Greg & Bernadette O'Neill
137 Riverview Rd
Avalon Beach. NSW 2107
30 January 2025

RE: DA 2024/1794 –139& 141 Riverview Rd, Avalon Beach

As immediate southern neighbours to this proposed development, we have reviewed the documentation posted on Council's website on 18 December 2024 and submit the following comments. The detailed information submitted provides significant clarification to the images provided to us by the applicant's owners/architect at a meeting at our house on 11 December 2024.

South Elevation

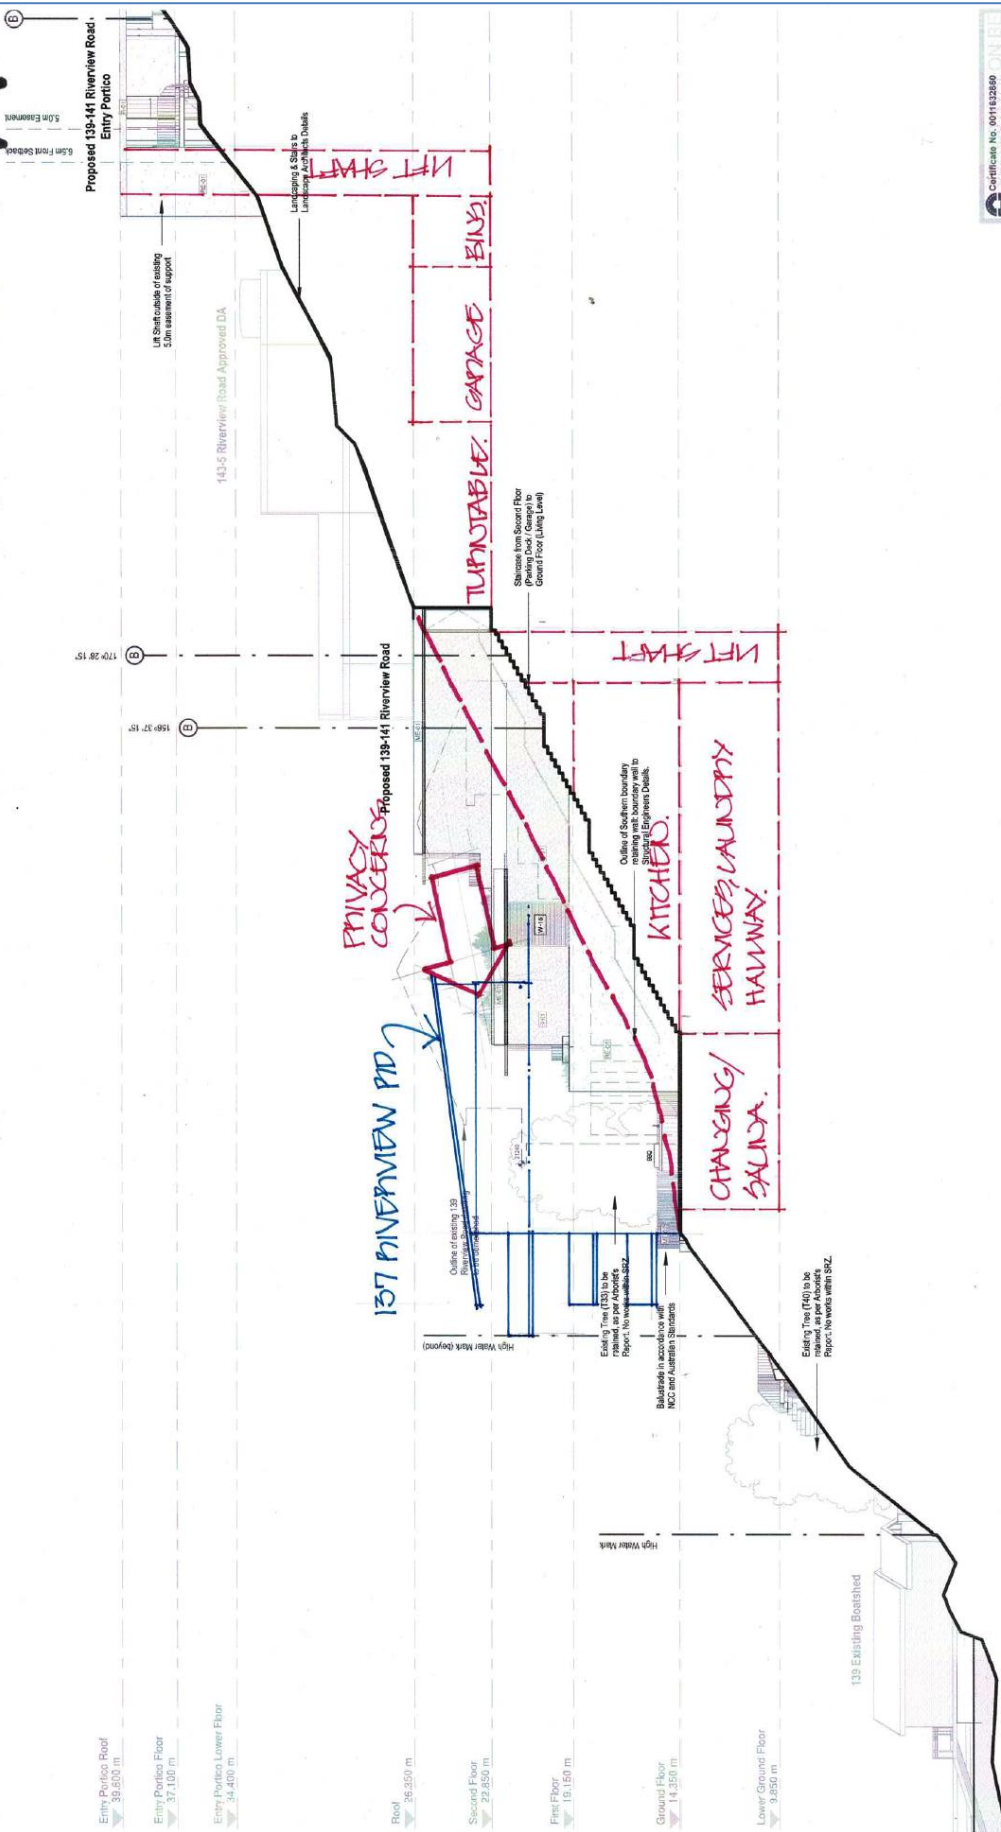
A major concern is the depth of excavation for the retaining wall that is proposed to be located directly on our northern boundary. This retaining wall, to create a 1.0m wide external stair from the 2nd floor to the GF, and a BBQ area at the GF, varies in height from 1.0 to 12.5m high, over a length of 27 metres. This is to be topped with a 1800mm high fence. Attachment A provides a marked up South Elevation showing the position of our house relative to the proposed development and an outline of the proposed excavation.

The proposed 1.0m southern access stair width does not make any provision for the thickness of the retaining wall as it fully accounts for all the space between the dwelling and the boundary. The construction of this wall will require some significant engineering. If requiring piers this wall could possibly be in the order of 500mm thick. If this is the case, to avoid any intrusion into our property, the stair cannot be the width currently shown. If a 1.0m wide stair is required, the dwelling will need to be located further to the north by a minimum 500mm. Even with this relocation, the proposal would provide zero setback for landscape to the common boundary and we would be left with no landscape screening to the proposed dwelling. The stair location is completely inappropriate in consideration of

the setback and should be relocated to the north of the dwelling. With a site width of over 26m, we consider that the proposed dwelling should be located 2.5m off our common boundary as an appropriate siting. This would also serve to minimise the issue of extreme depths of excavation directly against our boundary.

ATTACHMENT B

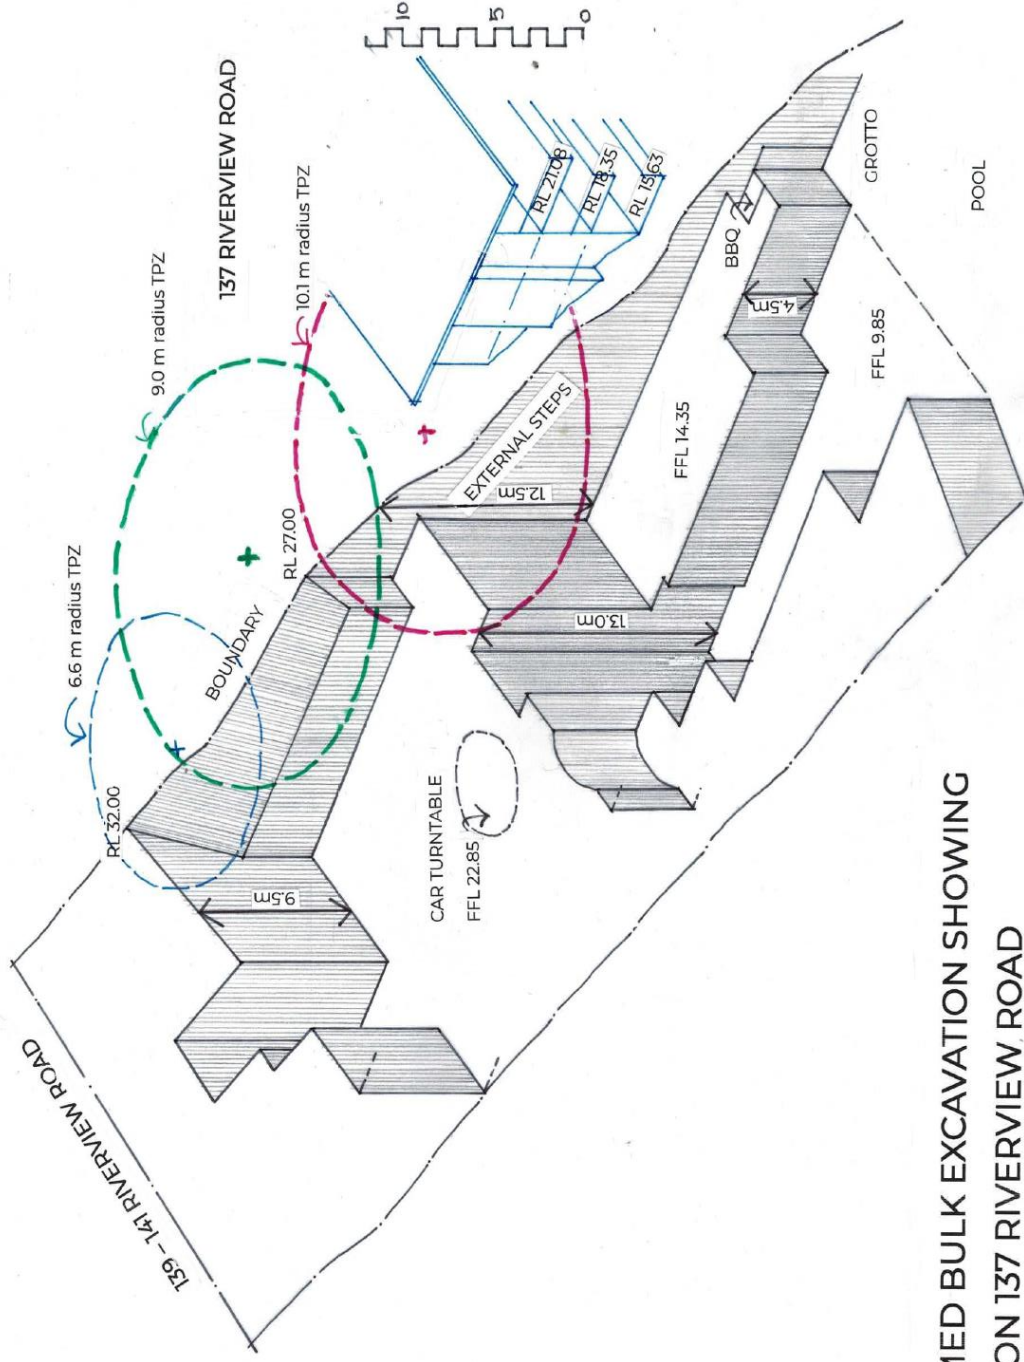
The proposed dwelling has been lowered into the sloping site attempting to achieve compliance with the height limits. This has limited the visual impact, overshadowing and some privacy issues for us. It does however result in extreme excavation requirements. Excavation depths for the LGF of the house range from approximately 3.0m at the western perimeter to something like 15.0m at the eastern perimeter. The underground garage requires excavation up to approximately 9.0m depth. The lift shaft to the Riverview Rd carport from the garage requires excavation of 11.0m. Overall these depth requirements combined with the size of the dwelling will result in the removal of not hundreds, but thousands of cubic metres of excavation. The Statement of Environmental Effects at Cl 7.2 describes the proposal as requiring "some excavation". Attachment A is a view of the excavated site. Attachment B & C illustrates the extent of the proposed excavation.

It is noted that the excavation plans (DA 420) does not indicate the additional excavation required for the 600mm drainage/ventilation voids shown on the architectural plans nor the excavation required for the foreshore flat lawn.
